Marion Stone Appeal

Subject: NRPA Supplement No. 6
L-24089-4h-A-N, Stone and L-24088-4-H-A-N Kohlberg Seawall Replacement and Modification,
Scarborough Beach, Scarborough, Maine

Subject: NRPA Supplement No. 7
L-24089-4h-A-N, Stone and L-24088-4-H-A-N Kohlberg Seawall Replacement and Modification,
Scarborough Beach, Scarborough, Maine

Subject: NRPA Supplement No. 8
L-24089-4h-A-N, Stone and L-24088-4-H-A-N Kohlberg Seawall Replacement and Modification,
Scarborough Beach, Scarborough, Maine

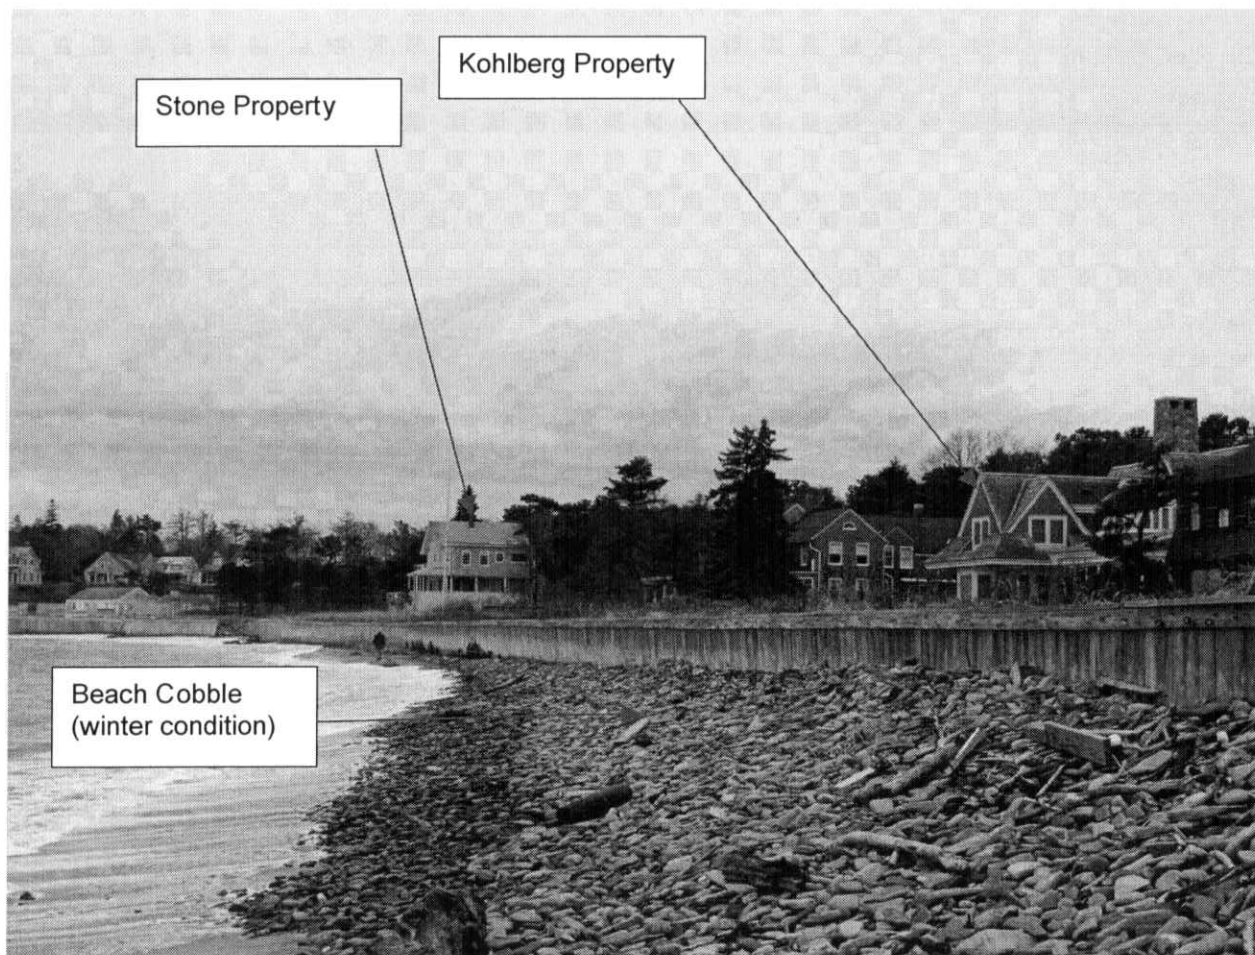
- B. **Scale contrast**, which is determined by the size and scope of the proposed activity given its specific location within the viewshed of a scenic resource; and

The elevation of the stone revetment matches that of the timber bulkhead that it replaces. The project also includes sand dune nourishment that raises the height of the dune landward of the revetment.

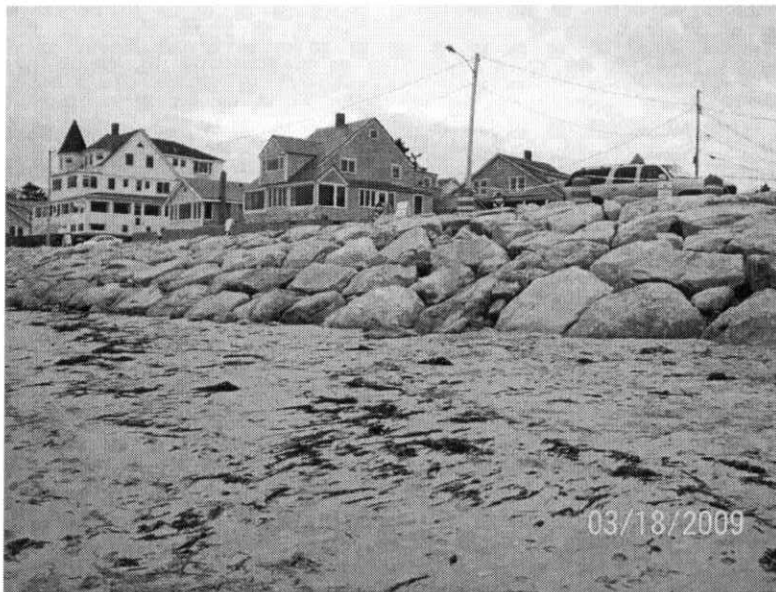
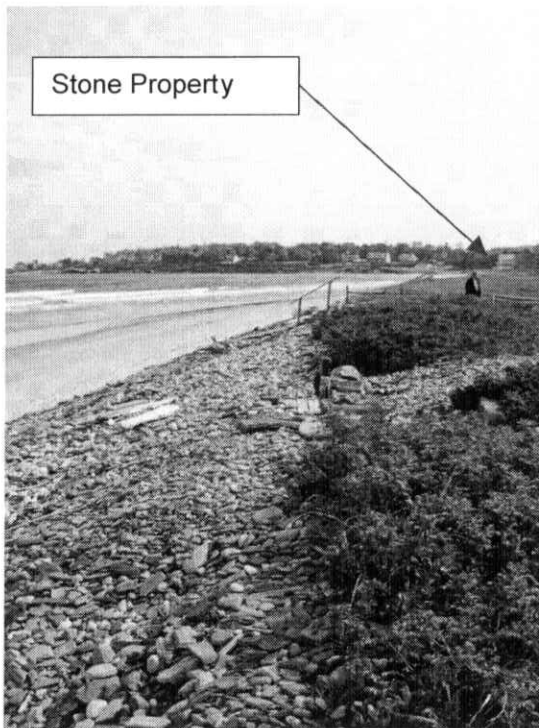
- C. **Spatial dominance**, which is the degree to which an activity dominates the whole landscape composition or dominates landform, water, or sky backdrop as viewed from a scenic resource.

The proximate footprint of the sloped stone revetment is larger than the vertical bulkhead that it replaces. This has been minimized by incorporating the steepest practical slope in the revetment design. When viewed from afar, the existing and replacement structures have a similar projection with the stone revetment being less dominant due to closer color and texture compatibility with natural beach cobbles.

SEAWALL TRANSITION AT PROPERTY LINE (SEE NOTE 1 FOR LOCATION)

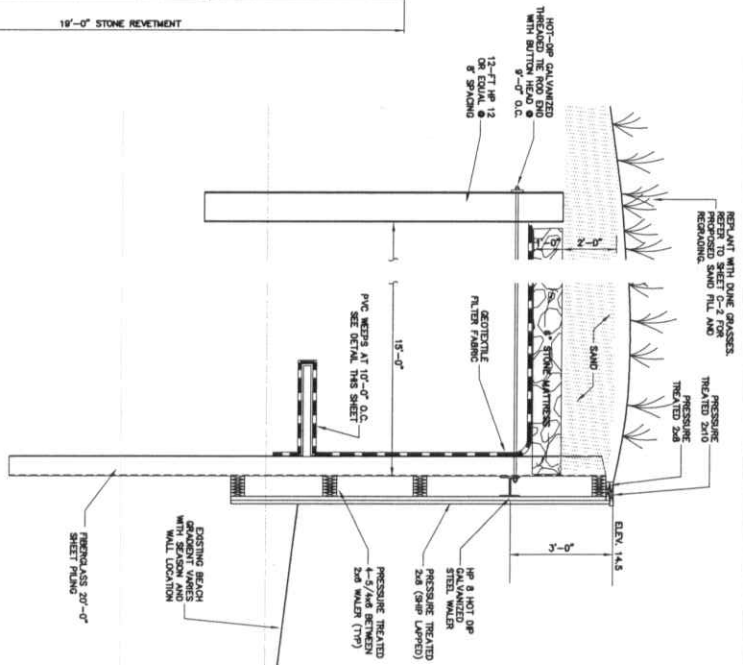
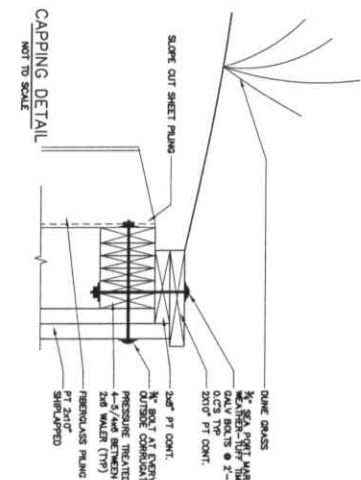
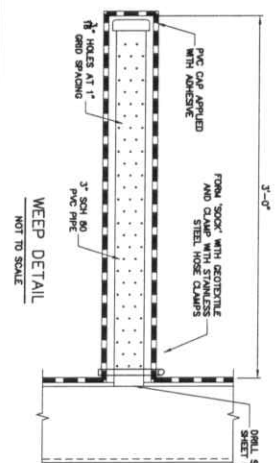
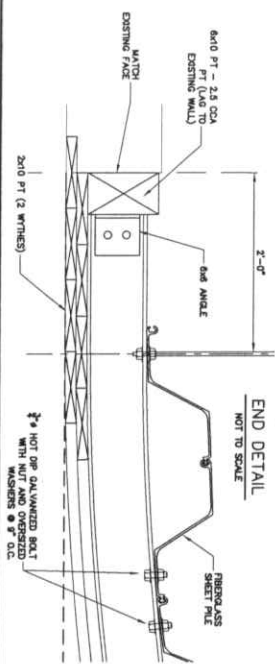
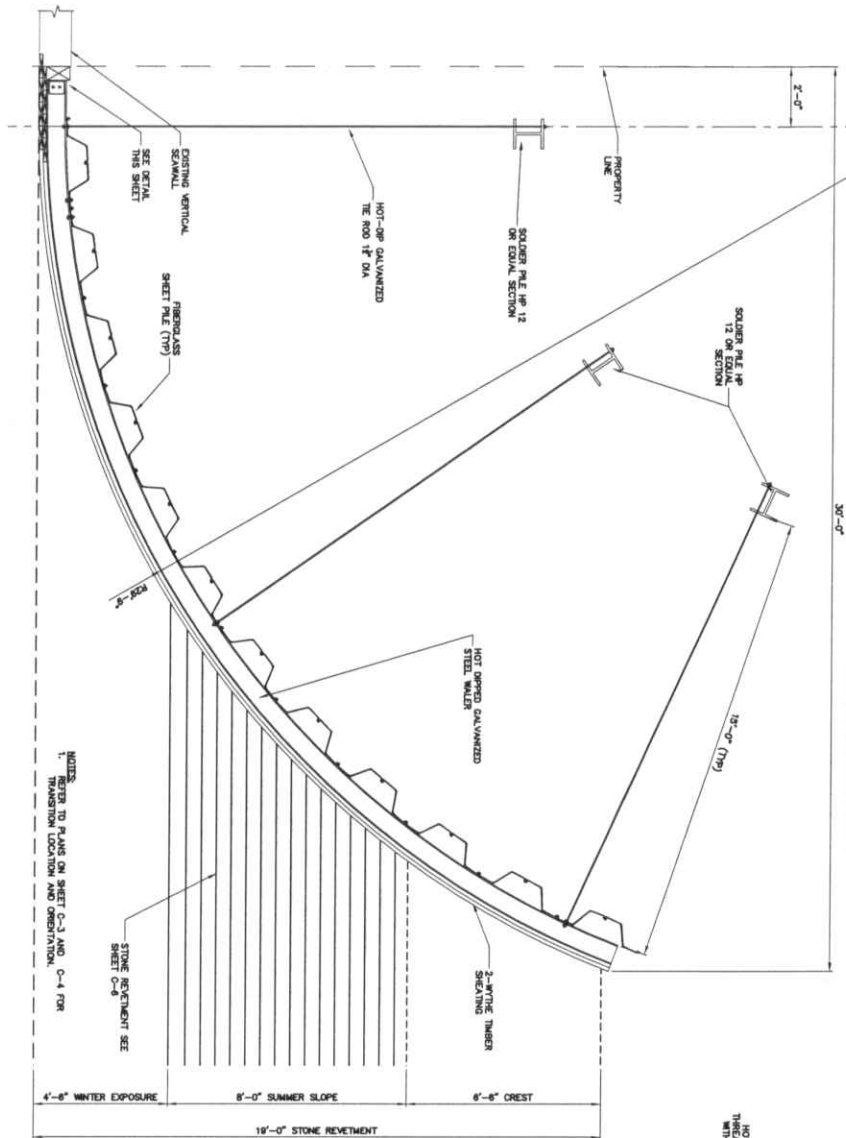
- Transition with adjacent properties- *There was agreement that the granite block abutments currently in the design should be substituted with a more gradual transitional design that blended the existing timber bulkhead and sloped revetment structures without the need for a special structure.*

- Marine Mattress Justification- *The need for the marine mattress shown on both the replacement bulkhead and the revetment solutions was questioned by Steve at the meeting because of the 'entrapment of sand' that effectively isolated material from the sand dune system*

Refer to Proposed Plan and Profile drawings C-3 and C-4. The granite block abutments have been replaced with a curved timber faced vertical bulkhead that creates a more gradual transition with the stone revetment. With this geometry, no significant end effects due to 'localized wave action' develop. The Woods Hole Group estimate the net energy impact will be within a range of an '0 to 0.5 times' increase. This should be regarded as a minimal impact in the context of comparable discontinuities in alignment and beach profile along the shorefront properties that currently exist.

Sheet C-7 Seawall Transition provides details for the construction of the seawall transition. The wall is similar to the PNBA wall in that hidden composite sheet piling provides long-term strength and constructibility, while the exposed timber sheathing matches the existing timber bulkheads.

Refer to Sheet C-6 Stone Revetment. The marine mattress has been eliminated. The revised section includes a bedding layer, and under layer and an armor layer of progressively larger stones.
